PRODUCT SAFETY NOTICE
FR Escape Tether – 203500, 202730
August 29, 2011

FR ESCAPE TETHER REPLACEMENT INSTRUCTIONS

Part number 203500 and 202730

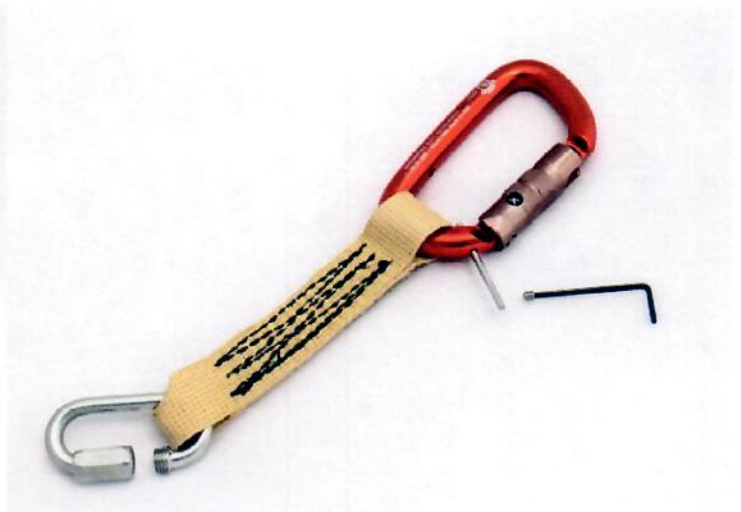
We have recently learned of one instance of the handle of the Escape Artist becoming temporarily caught in the oval screw link. We have not been able to duplicate this condition with the system under load; however, to eliminate any risk of this as a safety concern, we are offering replacement tethers with a different screw link free of charge to those who have purchased systems or tethers.

1. Remove the original tether by opening and removing the 7-mm oval screw link from the Escape Artist. You may need to use a wrench (12-mm or adjustable end) for this.

3. Remove the carabiner and install it in the replacement tether opposite the included 5-mm screw link.
4. Replace the keeper pin and set screw securely in the carabiner, making sure to capture the web below the keeper pin.

5. Install the replacement tether onto the Escape Artist with the new 5-mm stainless steel oval screw link. The smaller screw link is intentionally a tighter fit on the Escape Artist, so you may need to squeeze the side plates of the Escape Artist together in order to slide the screw link on. CMC recommends using a wrench (9-mm or adjustable end) to tighten the nut of the screw link. We also recommend periodic checks of both the screw link and carabiner to ensure that they are closed and locked prior to use.

TO MAINTAIN SYSTEM CERTIFICATION TO NPFA 1983, THESE INSTRUCTIONS MUST BE FOLLOWED, USING BOTH THE REPLACEMENT WEBBING AND SCREW LINK. SIMPLY SWAPPING THE SCREW LINK ONTO THE ORIGINAL TETHER VOIDS THE CERTIFICATION. THE SEWN NARROW END OF THE REPLACEMENT WEBBING IS NECESSARY TO ACHIEVE REQUIRED PERFORMANCE WITH THE 5-mm SCREW LINK.
